M4 Junctions 3 to 12 Smart Motorway

Non-Material Change
Junction 8/9 No Through Junction Running
Technical Note

Document Number: HA514451-CHHJ-GEN-SZ-ZZZZZZZZ_Z-TN-KK-0020

April 2022

Figure 3 Schematic showing layout of junction 8/9 with TJR

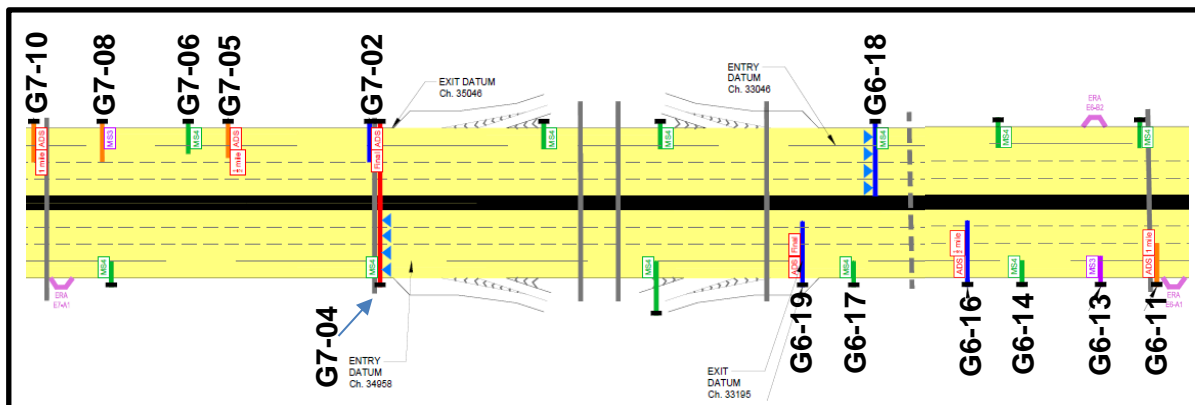
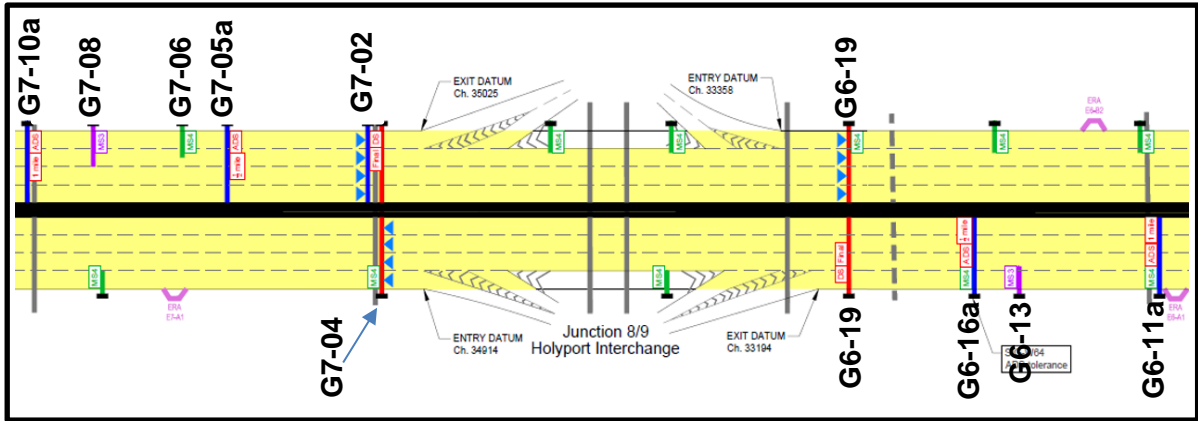
Figure 3 shows a schematic of the previously proposed location/order of gantries on both approaches to junction 8/9, whereas Figure 4 shows the new proposed layout of junction 8/9 (with No TJR).

The details eastbound and westbound gantries are provided in **Error! Reference source not found.** and Table 3 respectively. The changes to gantry location between TJR and No TJR are shown.

The junction is proposed to run as No TJR, also known as Dual 3 Lane Motorway (D3M). Three lanes and a hard shoulder in each direction will remain through at the intra junction. The retention of hard shoulder through the junction will provide a place of relative safety.

Figure 6 Noise level changes (DS22 No TJR) minus (DS22 With TJR)

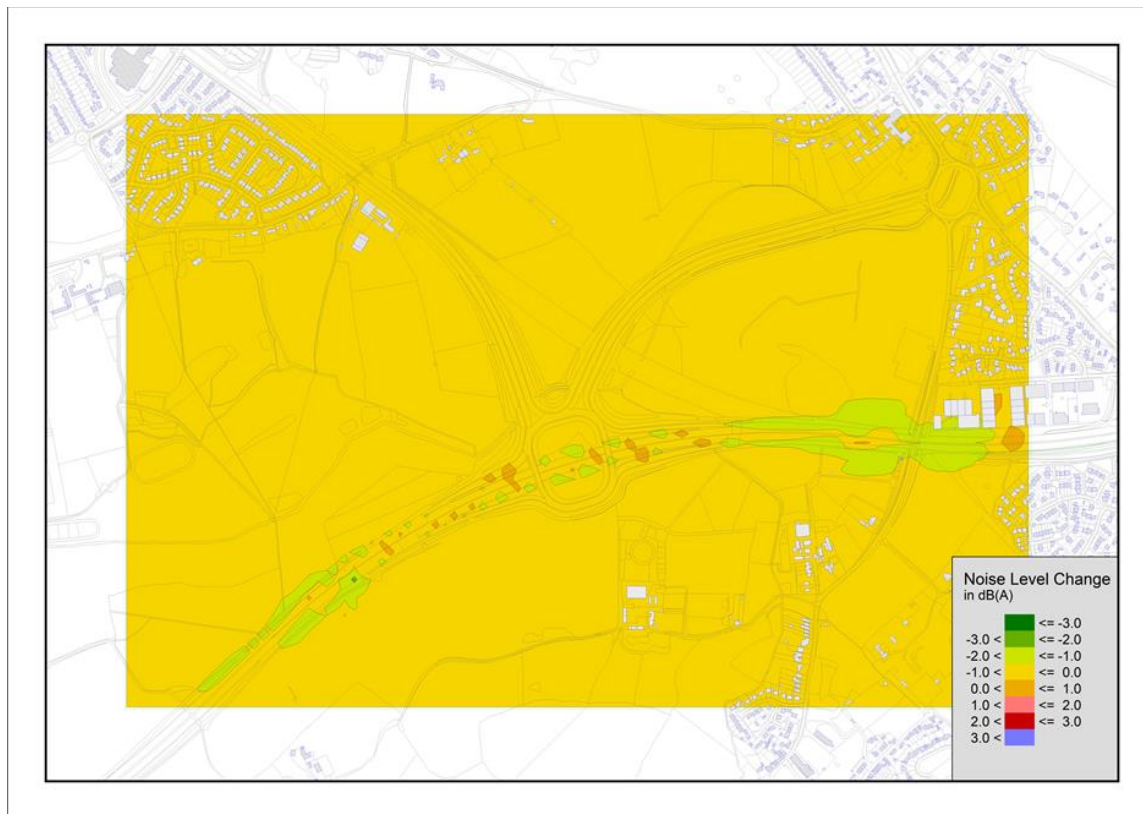
Figure 6, below, shows the noise level changes (DS22 No TJR) minus (DS22 With TJR).

It can be seen that there are generally negligible noise level decreases across the surrounding area as a result of adopting No TJR when compared with TJR.
